Access Compliance Report

Public Rights-of-Way

Intersection ID: 30317	Main Street: FLYING_SCOTSMAN_DR	Cross Street: ROCKET_LN	Location: W
ADA ID: 8B9AE7441852	Ramp Type: PerpDiag	Initial Pass/Fail: Fail	Overall Compliance: No
		Severity Score: 8.75

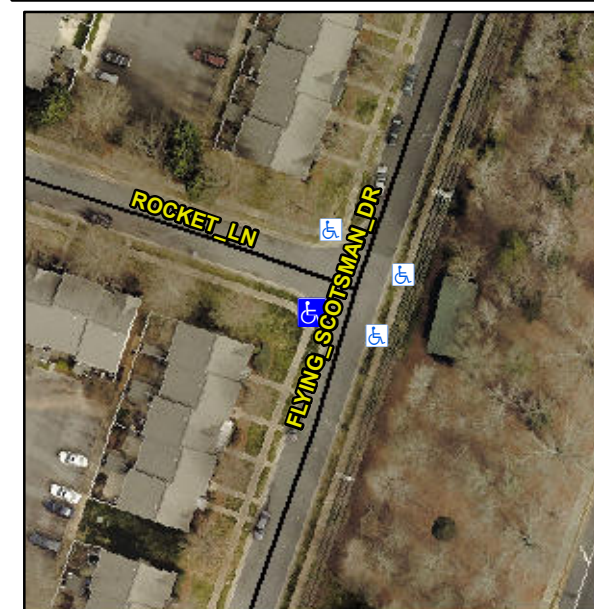
Not Found, R304.5.1

Compliance	Description	Data	Compliance	Description	Data
N/A	Ramp Length (in)	50.0	Yes	Ramp Slope (%)	7.5
No	Ramp Width (in)	42.5	Yes	Ramp XSlope (%)	1.0
N/A	Flare Type LT	N/A	N/A	Flare Type RT	N/A
N/A	Flare Slope LT (%)	N/A	N/A	Flare Slope RT (%)	N/A
N/A	Flare Traversable LT?	N/A	N/A	Flare Traversable RT?	N/A
N/A	Landing Length (in)	N/A	N/A	DWS Provided?	N/A
N/A	Landing Width (in)	N/A	N/A	DWS Contrast?	N/A
N/A	Landing Slope (%)	N/A	N/A	DWS Length (in)	N/A
N/A	Landing X Slope (%)	N/A	N/A	DWS Full Width?	N/A
N/A	Landing Curb? (Y/N)	N/A	N/A	DWS Offset (in)	N/A
N/A	Shared Landing?	N/A			
N/A	Gutter Ponding?	N/A	N/A	Gutter Slope (%)	N/A
N/A	Gutter Lip Ht (in)	N/A	N/A	Gutter X Slope (%)	N/A
N/A	Painted X Walk1?	No	N/A	Painted X Walk2?	No
	X Walk 1 Direction	To SE		X Walk 2 Direction	To NE
N/A	X Walk 1 Width (in)	N/A	N/A	X Walk 2 Width (in)	N/A
	X Walk 1 Slope (%)	4.6		X Walk 2 Slope (%)	1.6
	X Walk 1 X Slope (%)	0.8		X Walk 2 X Slope (%)	2.6

Remove & Replace Curb Ramp With Two New Directional Ramps or Equivalent.
